**TECHNICAL SERVICE BULLETIN****Bulletin No.:** TSB-020**Date:** January 8, 2016**Subject:** PRD Manifold Mount**Models:** Generation 1 & 2 Frame Mount Fuel Storage Modules**Background**

All generation 1 & 2 frame mount FSMs have Pressure Relief Device (PRD) manifolds. The PRD manifolds are connected to a live port on the tank valve and are designed to safely vent the cylinder under certain conditions.

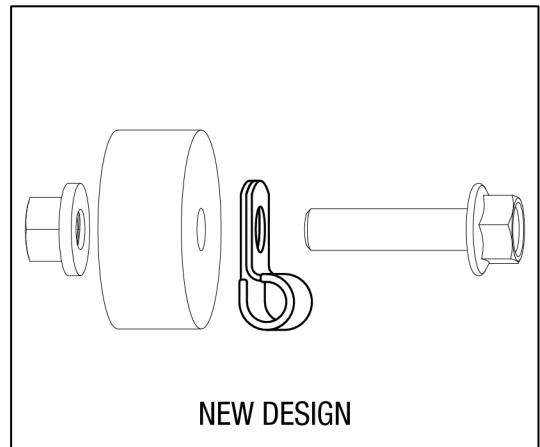
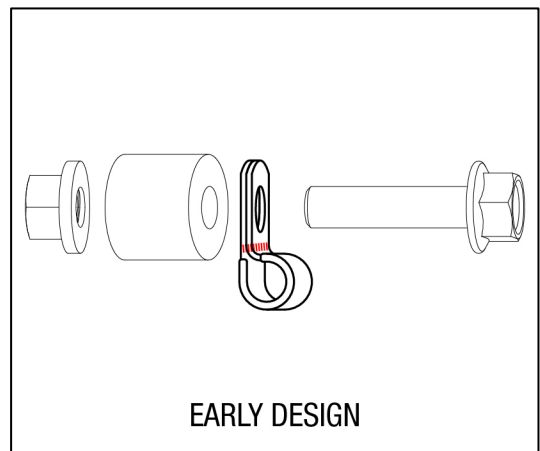
In some cases, the P-Clamp which holds the PRD manifold assembly in place, may fail and allow the PRD line to droop. If the PRD manifold is permitted to droop and is not corrected, then PRD valve damage or fuel leakage may occur.

Earlier PRD manifold assemblies used a smaller diameter vibration mount. Under certain conditions, the P-Clamp may fail against the vibration mount causing the PRD line to droop and cause the PRDs to contact the FSM covers.

Replace the PRD manifold mounts as necessary following the procedure in this bulletin.

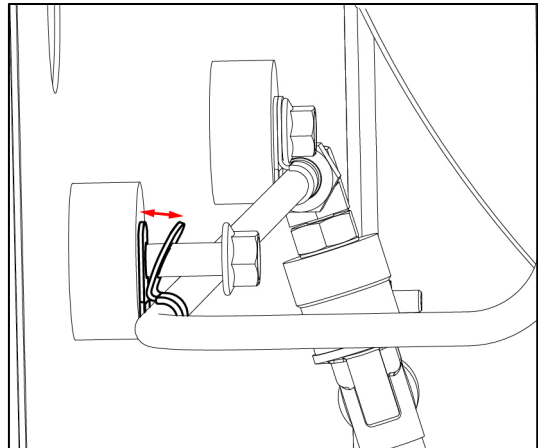
*While enlarging the PRD line mount hole with a 3/8" drill bit, use a drill shield and/or a drill stop so that the drill bit does not penetrate the cylinder. Failure to not use a drill shield and/or drill stop when enlarging the PRD line mount hole and penetrate the cylinder will result in death or serious injury.*

7. If necessary, some PRD mount holes may need to be enlarged. Once one of the PRD line mount has been removed from the rear panel, carefully enlarge the hole with a 3/8" drill bit.

8. Apply a zinc-rich primer to the exposed metal.
9. Loose-fit the PRD line mount hardware with the parts provided as shown in the illustration.
10. Repeat steps 7-9 until each PRD line mount has been replaced.

11. Tighten the PRD Manifold mount fastener until the gap in the P-Clamp closes. Once the gap in the P-Clamp is closed, then tighten the fastener an additional 1/2 turn. The rubber mount should be slightly compressed if properly tightened.
